REDLAND WOODS

MASTER DEVELOPMENT PLAN

PRELIMINARY OVERALL AREA DEVELOPMENT PLAN

RE: Redland Woods Subdivision POADP #353

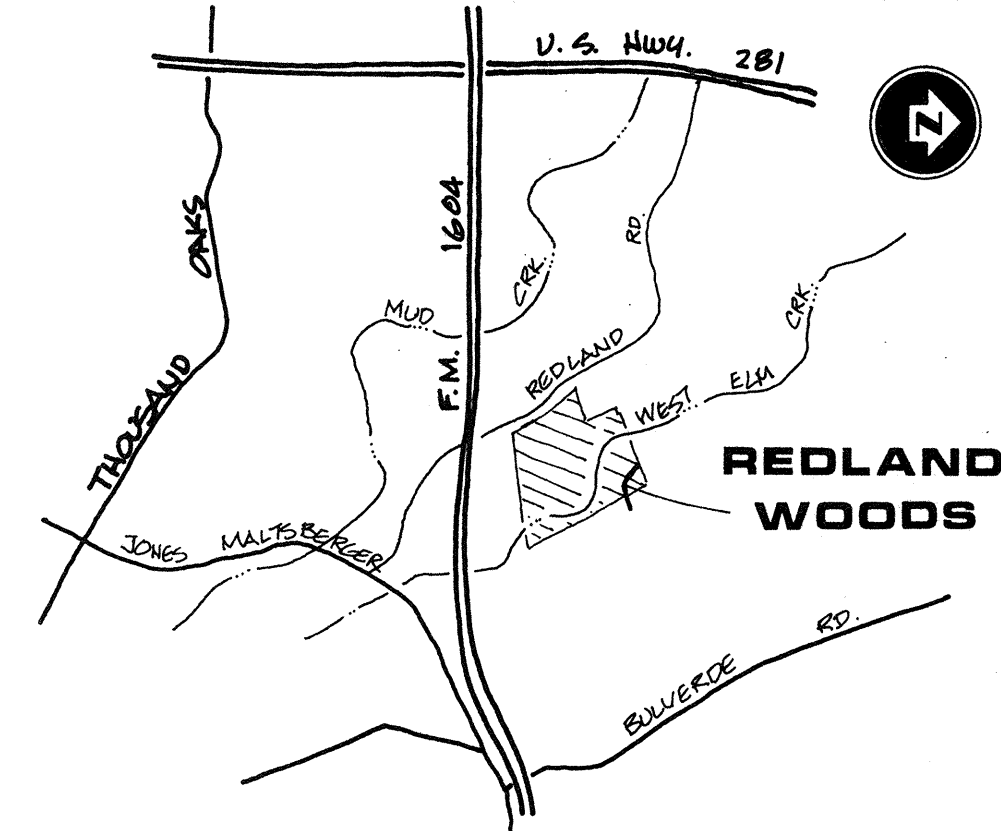
As per your most recent telephonic conversation with my staff, it is my understanding that you have agreed to cul-de-sac the proposed connection with Encino Summit. A cul-de-sac is preferred by city staff as previously delineated in our March 8, 1993 letter.

Additionally, the Traffic Design Engineer has suggested that the two additional longer streets north of Gold Canyon Drive be flared at their intersection with Gold Canyon as was done with the extension of Corporate Woods. The Traffic Design Engineer also prefers that both sides of the intersection with Corporate Woods on the southern half of the proposed development be flared. Flaring at all of these intersections will facilitate better traffic movements and smoother flow.

3-16-93 REVISED UNIT 1 - STREET # LOT LAYOUT DUE TO TREES JCH
 SCALE: 1" = 200'
 DATE:

Enclosed is a revised Master Plan for our 242 acre tract of land off Redland Road. The revision to the plan create a cul-de-sac in our unit 1, which eliminate a direct connection with Encino Summit Dr, as per your recommendations in your letter dated March 25, 1993.

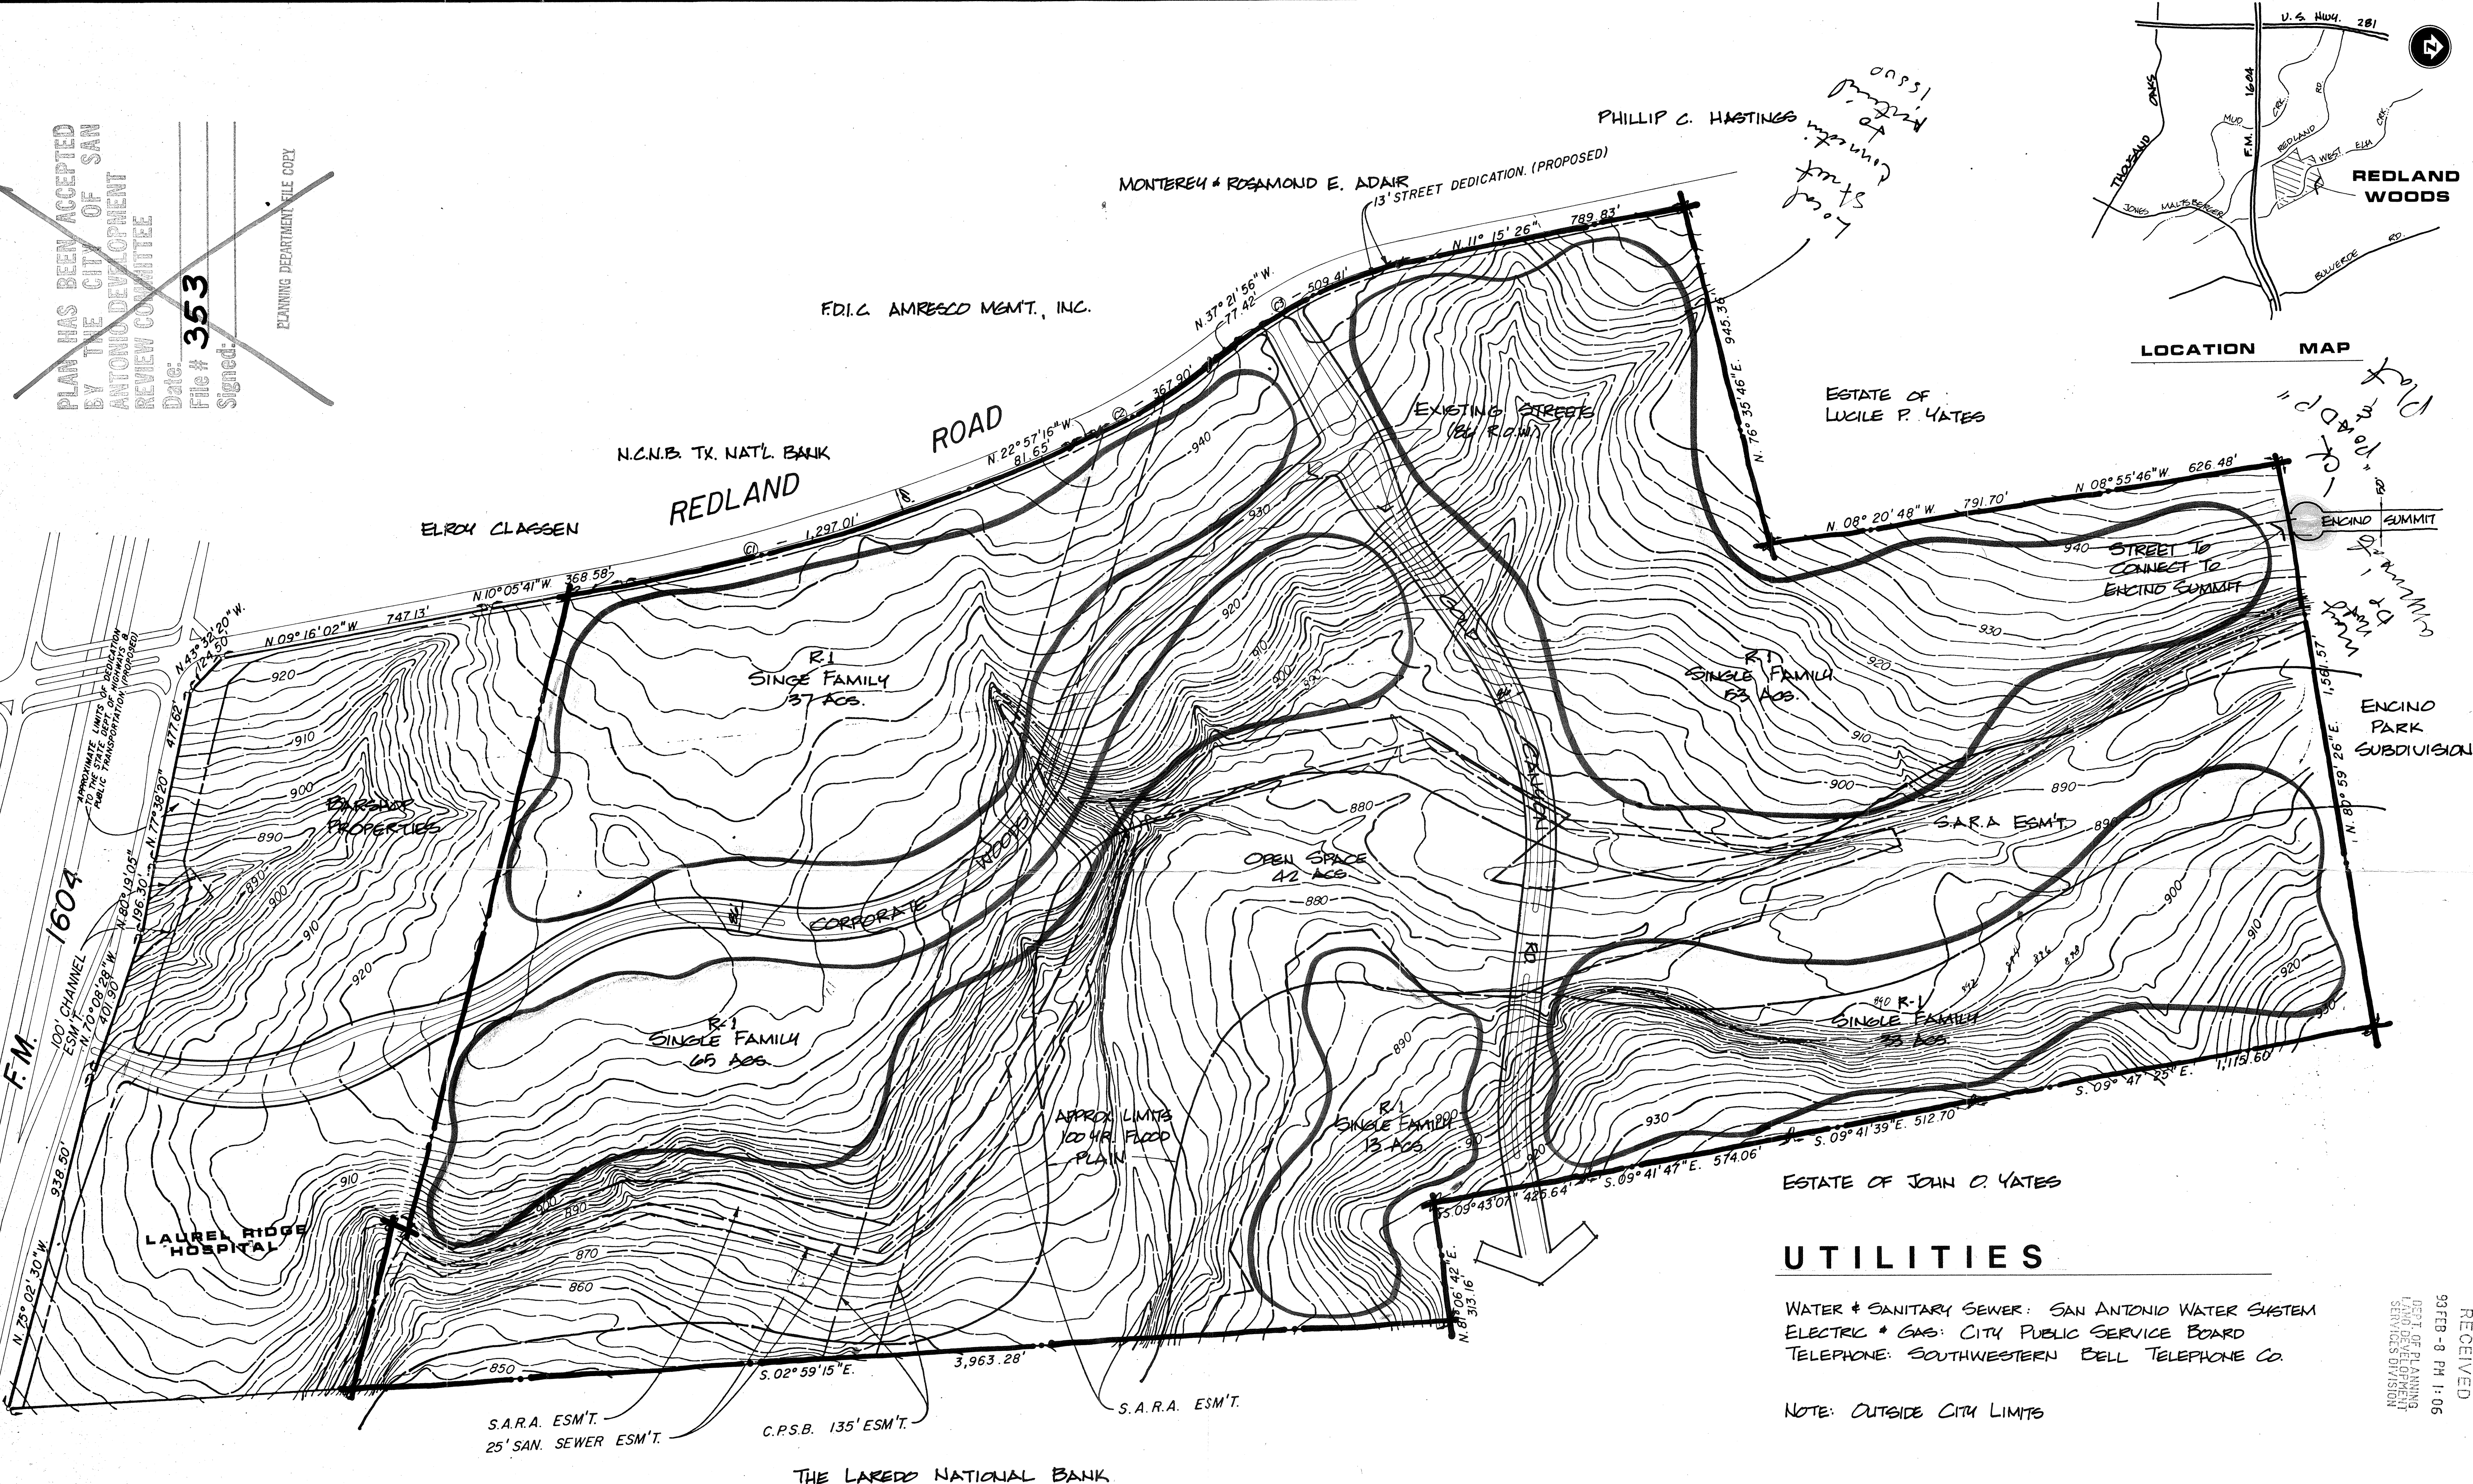
1. Local streets within your clusters of proposed residential development may not tie into arterial streets. Therefore, collectors need to be provided.
2. Your proposed connection to Encino Summit is not appropriate. Encino Summit was not designed as an arterial street.

Encino Summit is a long (approximately 1200 feet) residential cul-de-sac in the Encino Park Subdivision. The street width, character, and function are those of a Local, Type A, street.

The proposed Redland Woods Subdivision layout would cause this previously existing Local, Type A, street to have a direct connection to a Secondary Arterial, Type A, street, Gold Canyon Road. This is, of course, contrary to Policy #1.10 of the Major Thoroughfare Plan, which is stated as follows

"Reduce access points along arterial streets in developed areas by : (1) closing
(where this is practical) access to arterials from local streets; . . ."

In addition to the policy perspective, the specific effect of connecting Encino Summit to Gold Canyon will be to provide a shortcut between the large residential subdivision of Encino Park and Loop 1604 East. The results will be adverse to all residents of Encino Summit as well as other Encino Park streets with residential frontage, e.g., Encino Crown, Encino Cliff, etc.

Because these existing streets have residential frontage and serve as Local, Type A, streets, I recommend against pressing them into service as defacto collectors by connecting Encino Summit to Gold Canyon Road.

Staff analyzed the area of Redland Woods that would be most affected if Encino Summit were to be connected with Gold Canyon Road. This southern portion of Redland Woods is comprised of approximately 494 housing units. It is assumed that these 494 housing units will generate approximately eight to ten trips per day. It is also assumed that seventy percent of traffic traveling to and from the southern portion of Redland Woods will use the Encino Rio collector, while the remaining thirty percent would utilize the extended Encino Summit. Based on these assumptions, if Encino Summit is connected with Gold Canyon Road, the result would be a traffic increase ranging from 1,186 to 1,482 trips per day. For example:

Additionally, If Encino Summit, (Local, Type A) is directly connected to Gold Canyon Road (Secondary Arterial Type A), this would contradict the Major Thoroughfare Plan, more specifically, Policy #1.10 which states:

In summary, the Transportation Division recommends against connecting Encino Summit to Gold Canyon Road not only from a policy perspective, but from a welfare perspective as well.
